Retreat at TimberRidge

PRELIMINARY PLAN

EL PASO COUNTY, COLORADO

SP 182

PRELIMINARY PLAN

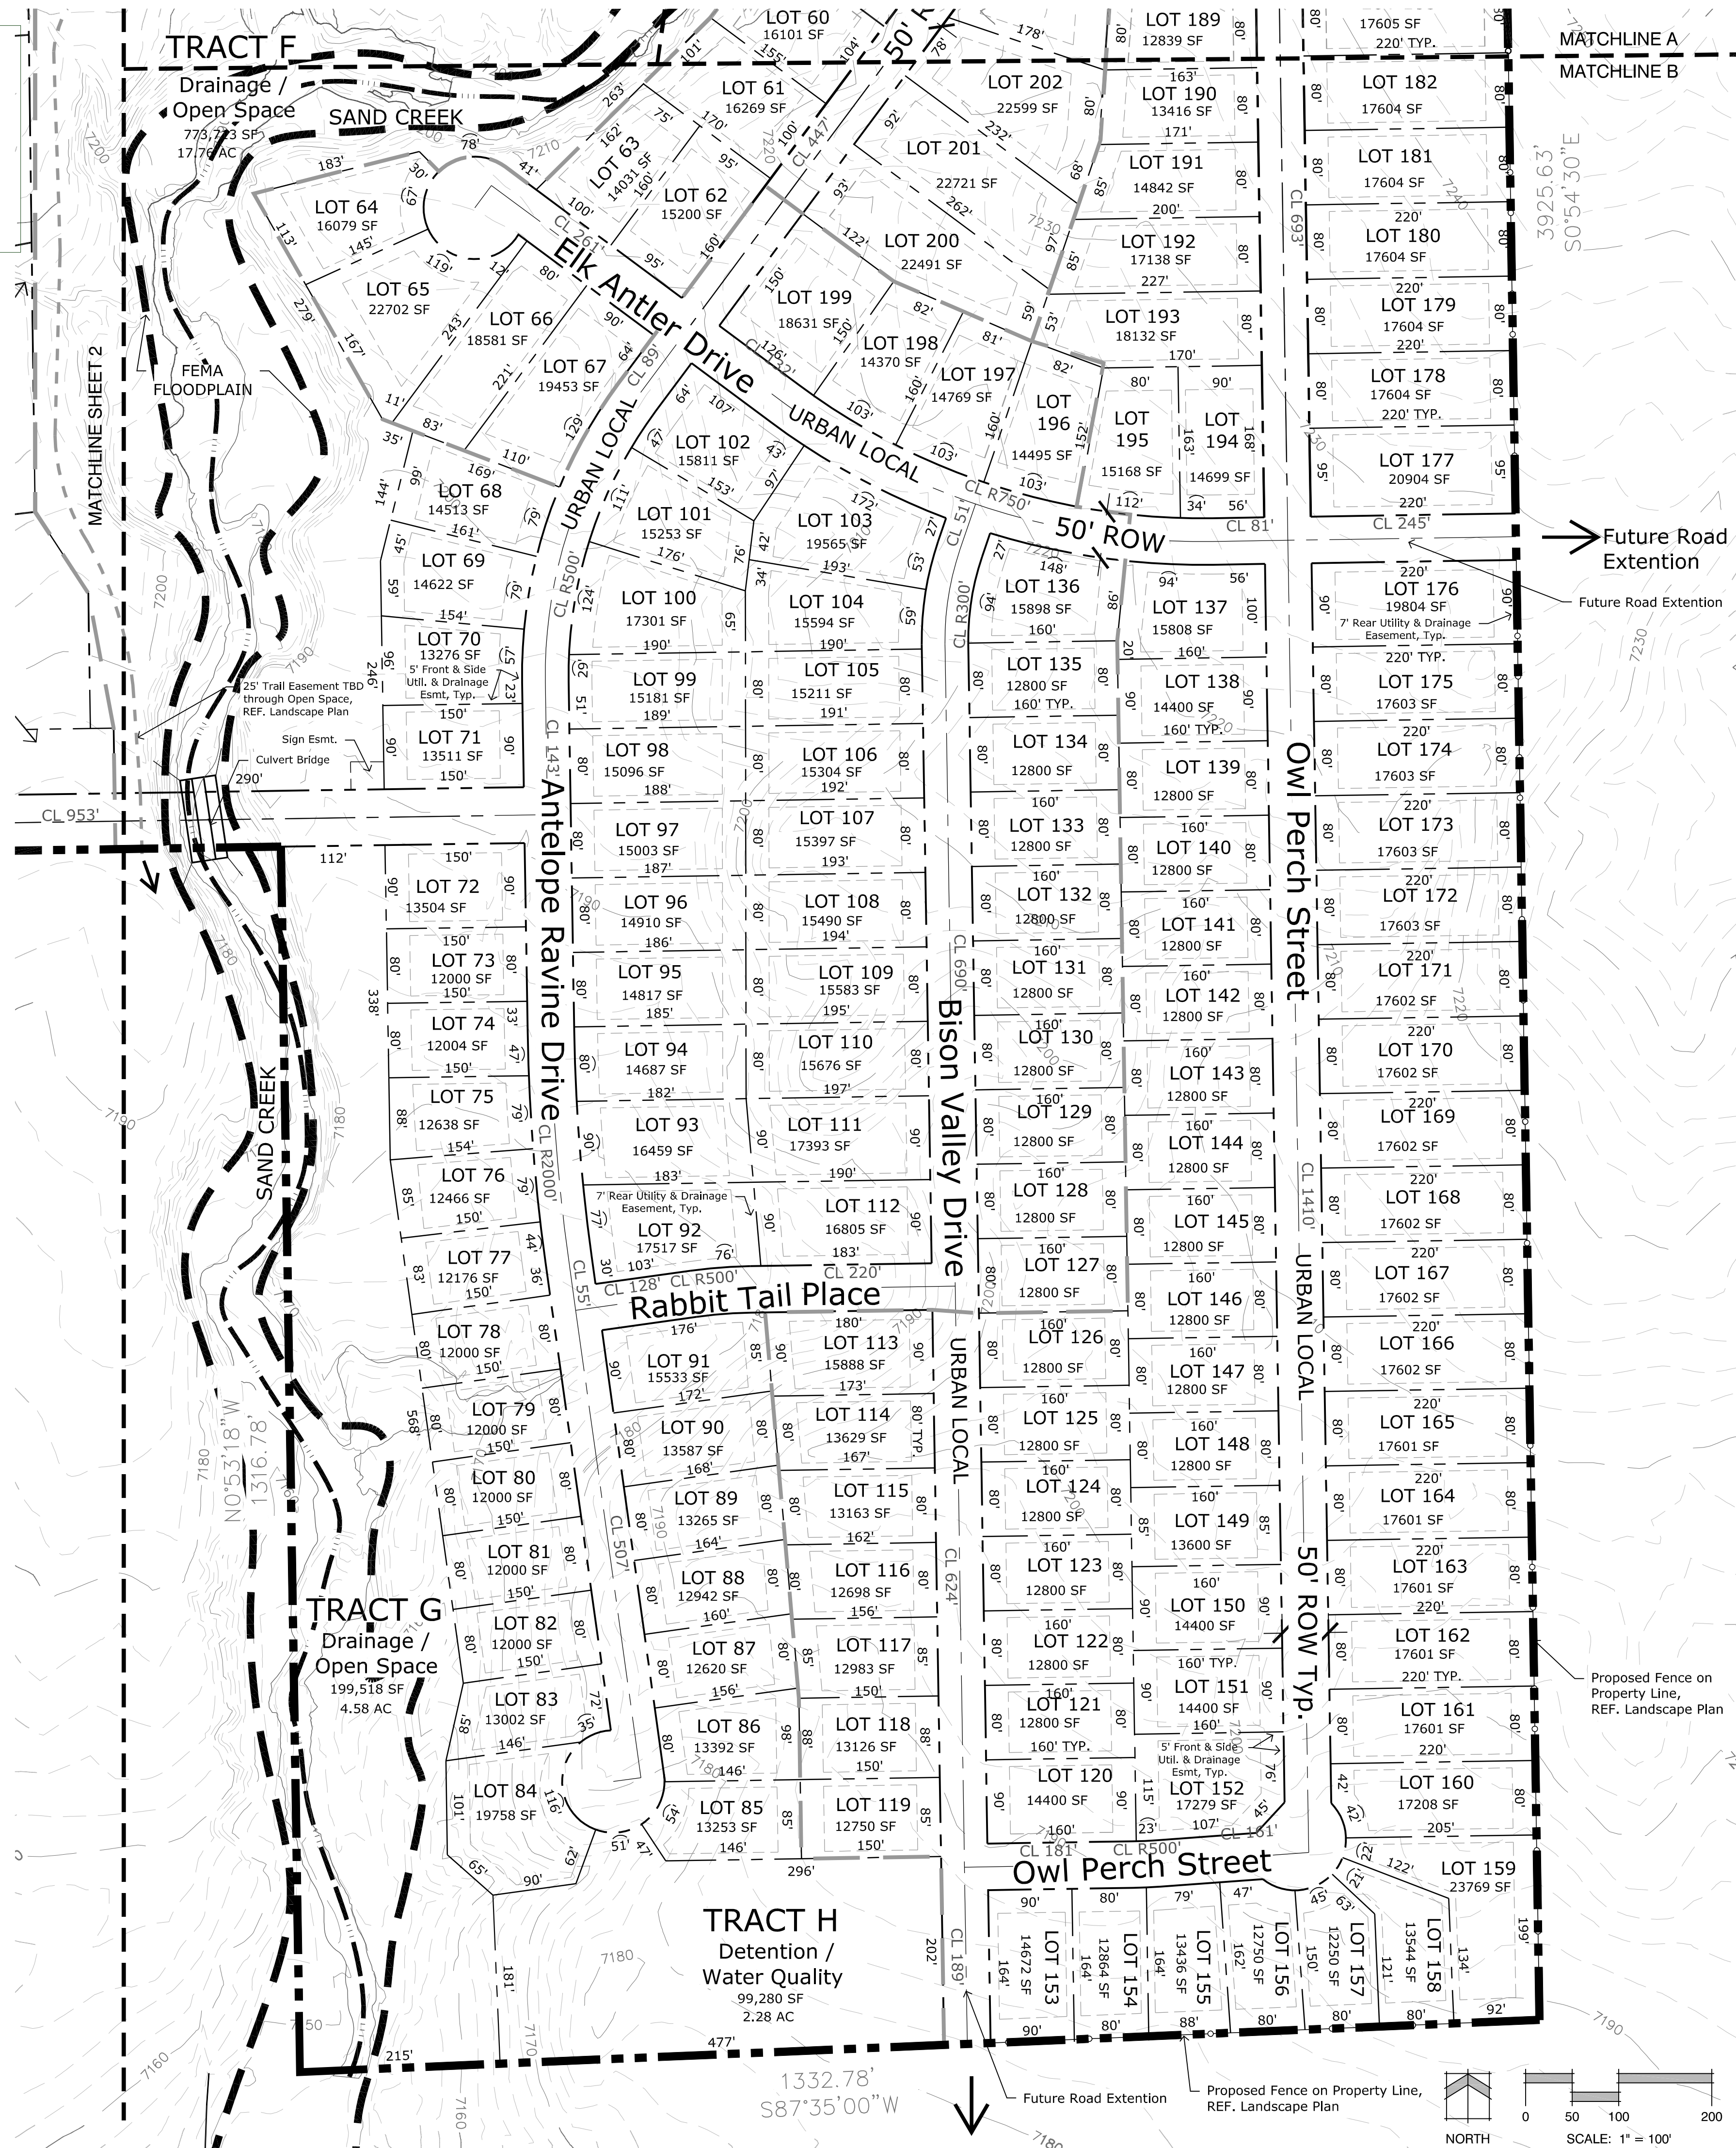
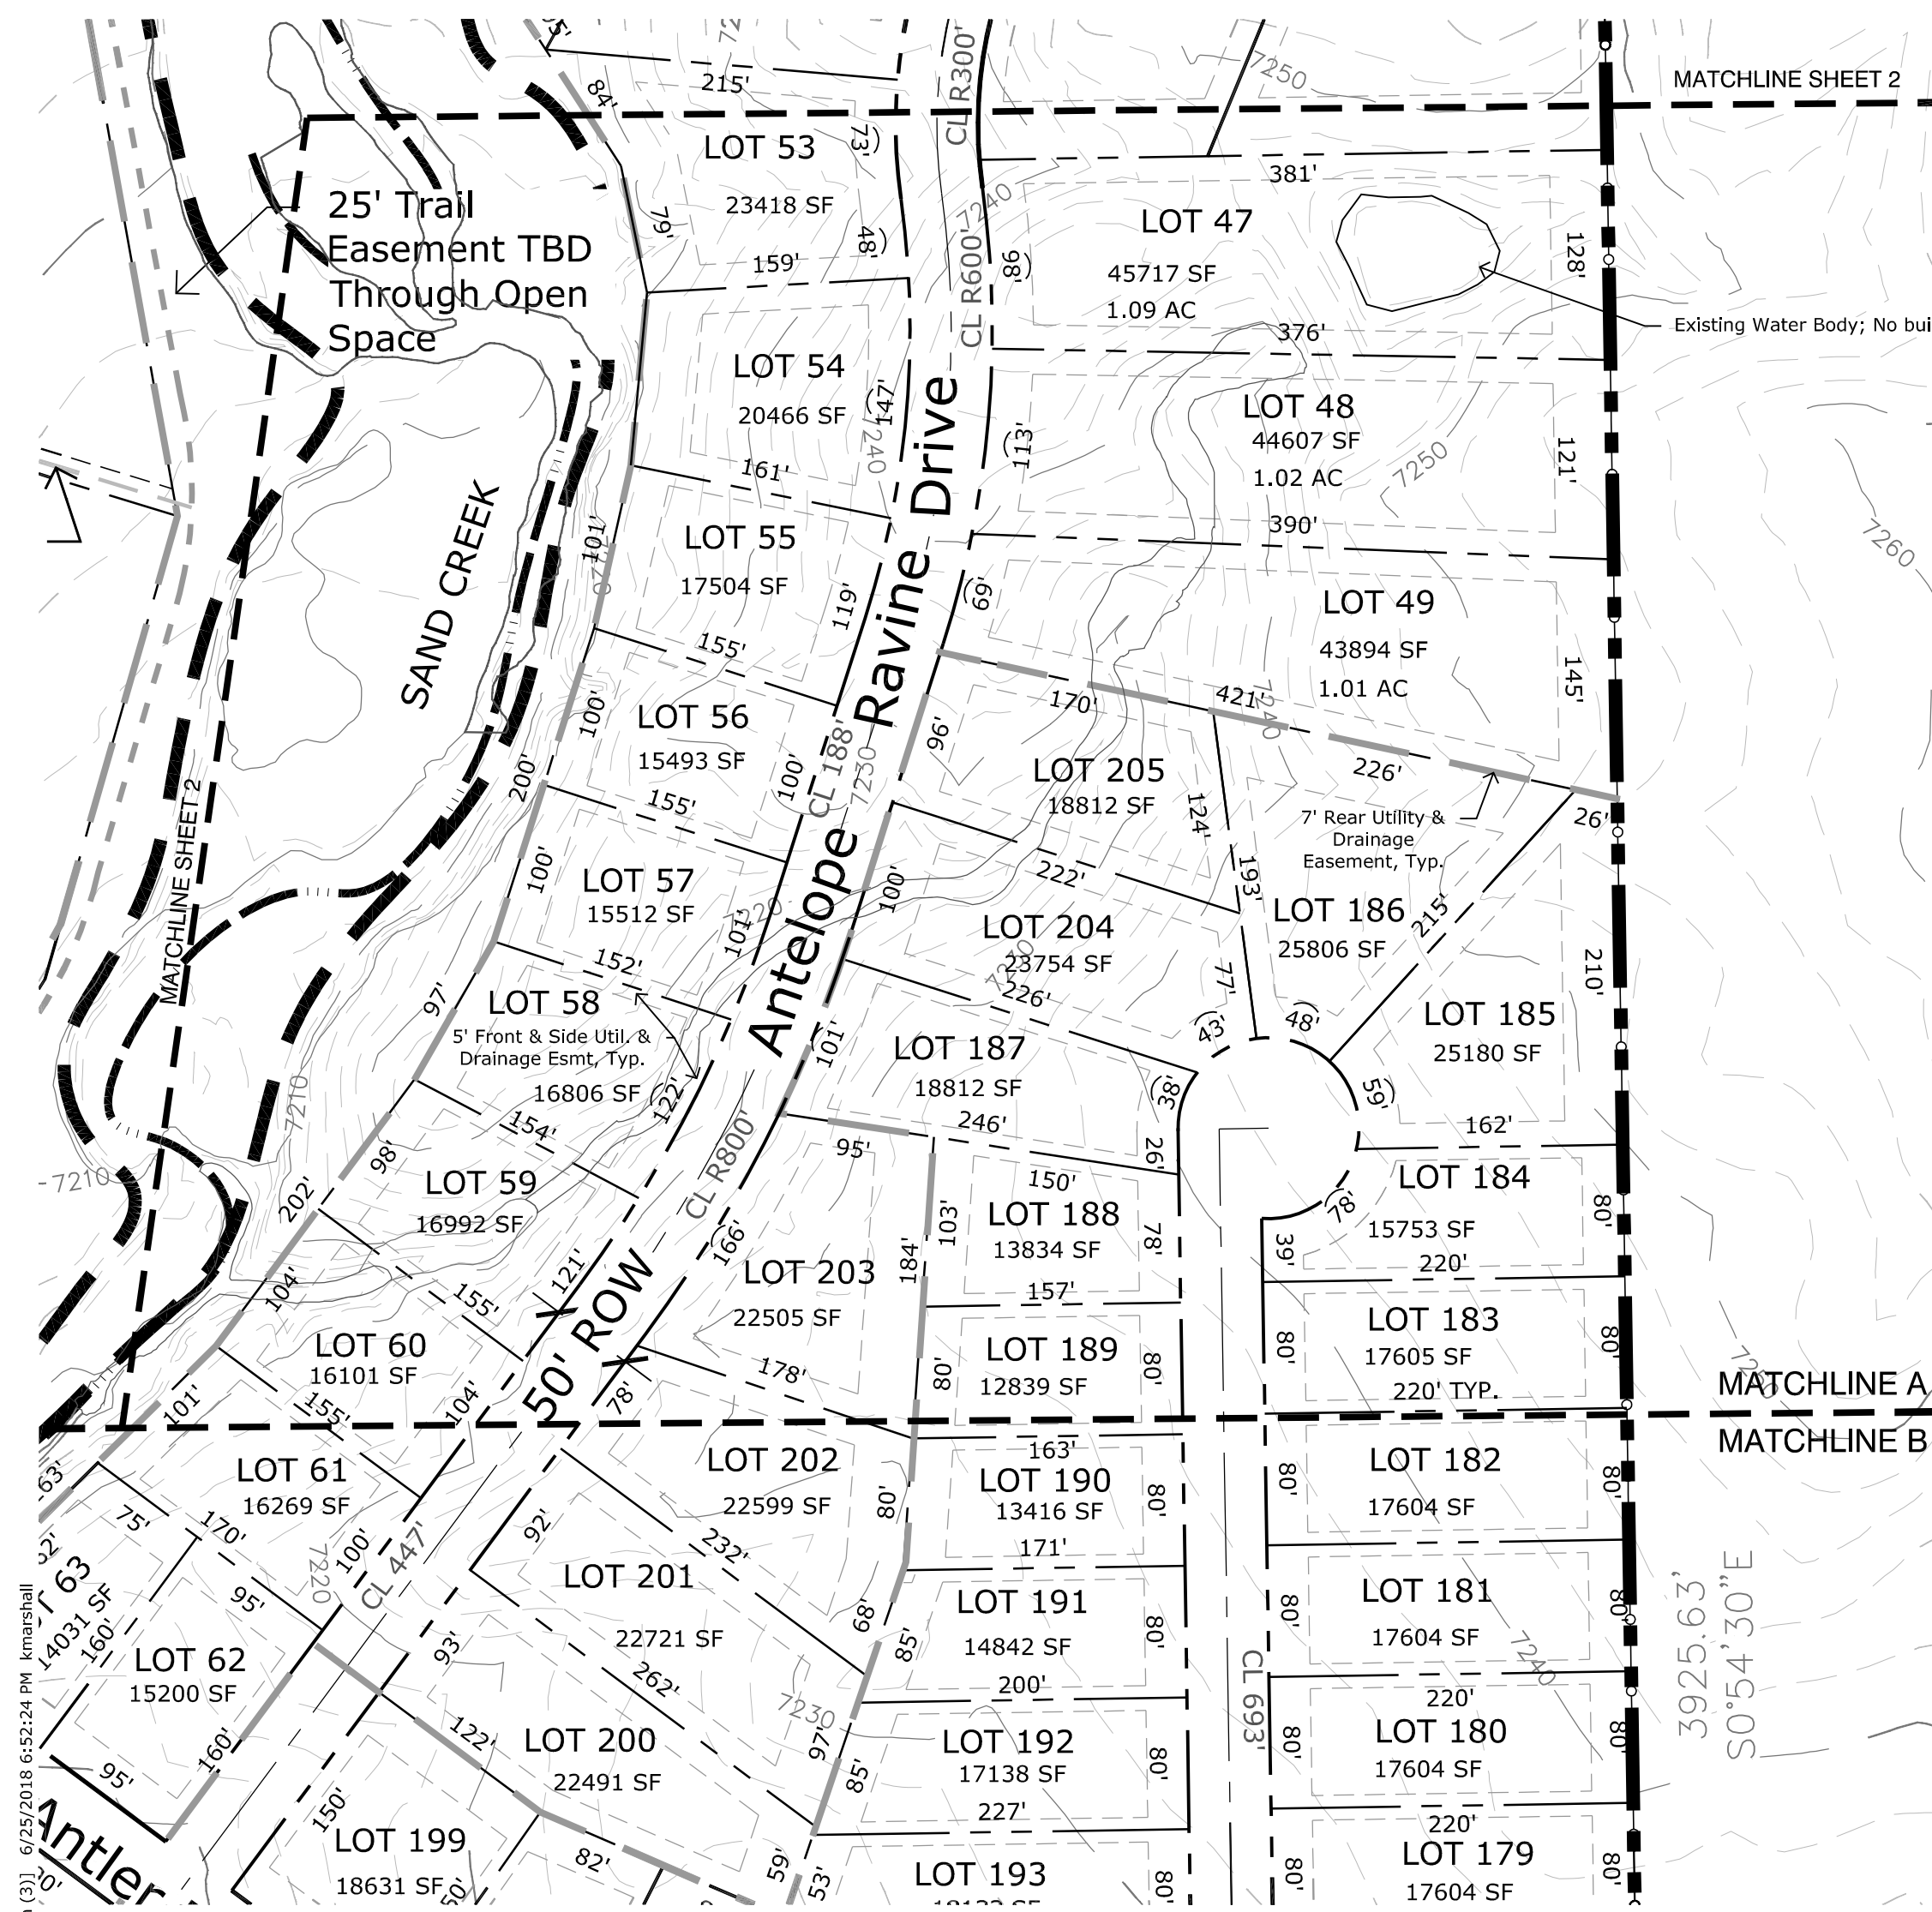
Add to each sheet in the prelim plan set *8 sheets (A) Title Block and Reference Information
 Name of proposed subdivision centered on the top of the plan and at the top of each sheet. On each sheet, a subtitle, in smaller lettering, shall indicate the quarter section(s)(1/4), section, township and range in which the subdivision is located. The name of the County and the State shall be included in the subtitle.

Add the distance bearings, dimensions off all lots. Both the old blue book Code and draft procedures require this on a prelim map.

Identify the wetlands and areas in lots that are to be preserved by no-build areas- all sheets where impacted OR identify no build areas on Constraints Map (sheets 4 and 5)

PRELIMINARY PLAN

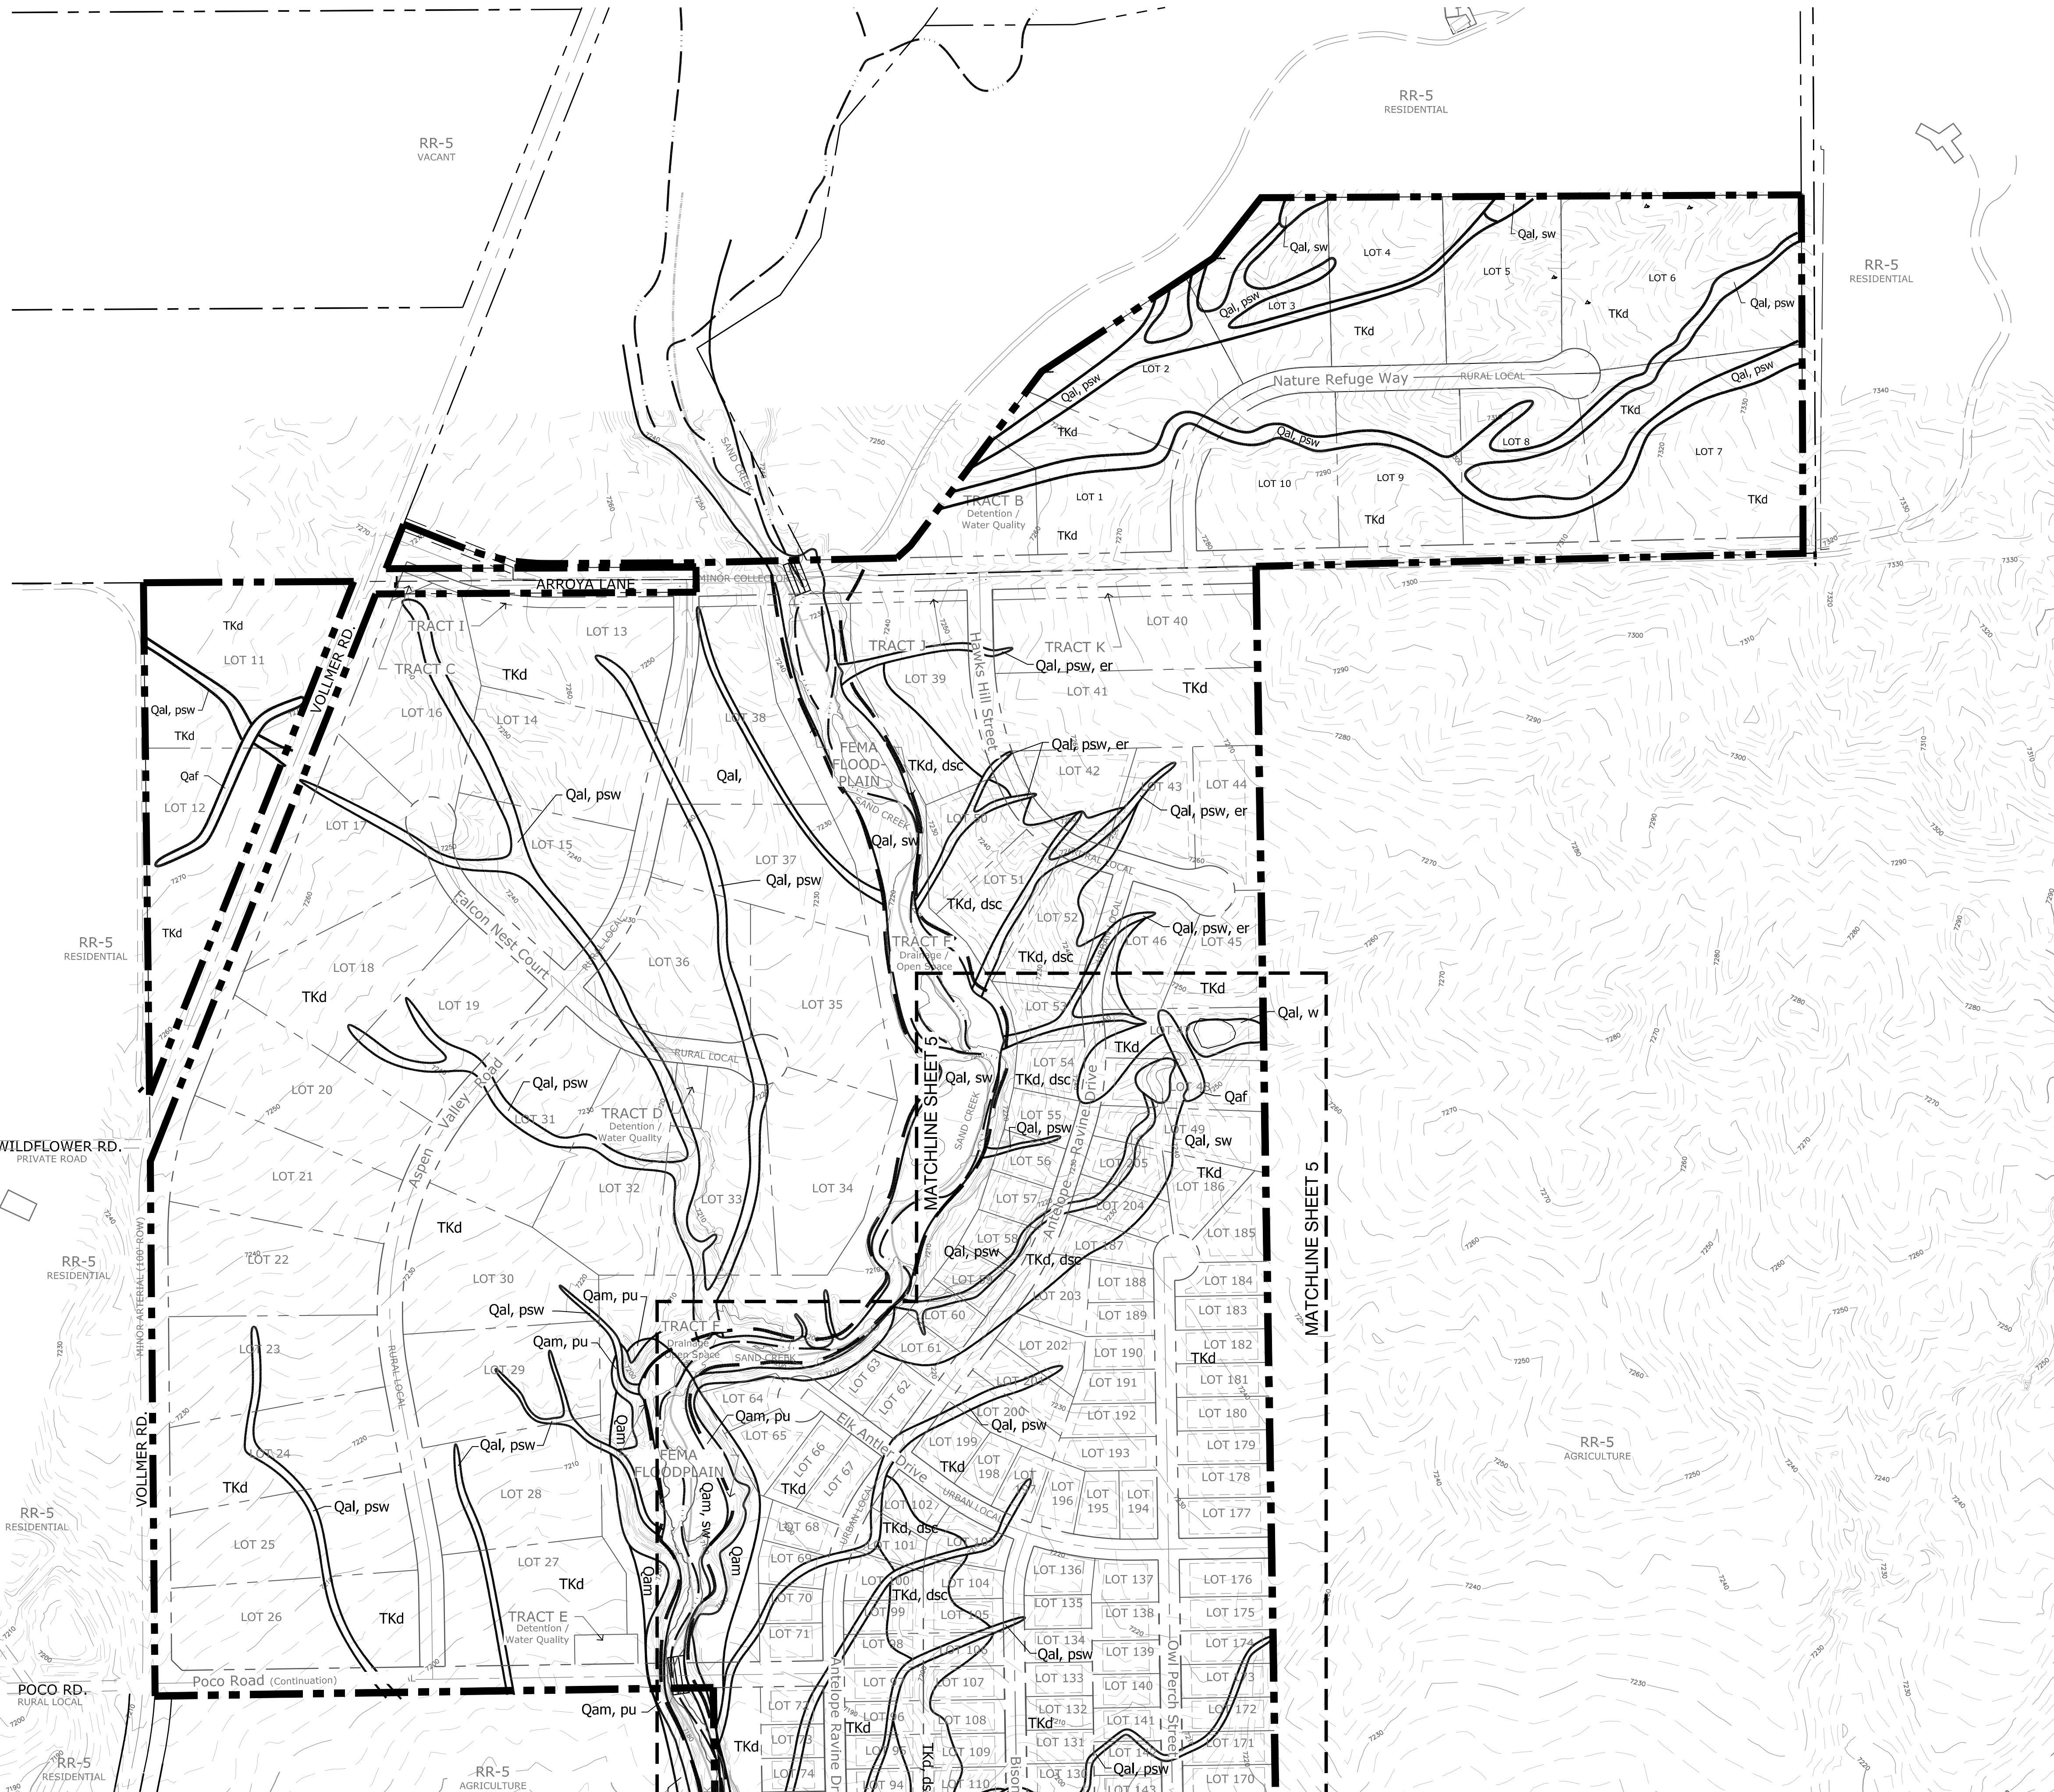
Add to each sheet in the prelim plan set "8 sheets" (A) Title Block and Reference Information
 Name of proposed subdivision centered on the top of the plan and at the top of each sheet. On each sheet, a subtitle, in smaller lettering, shall indicate the quarter section(s) (1/4), section, township and range in which the subdivision is located. The name of the County and the State shall be included in the subtitle.
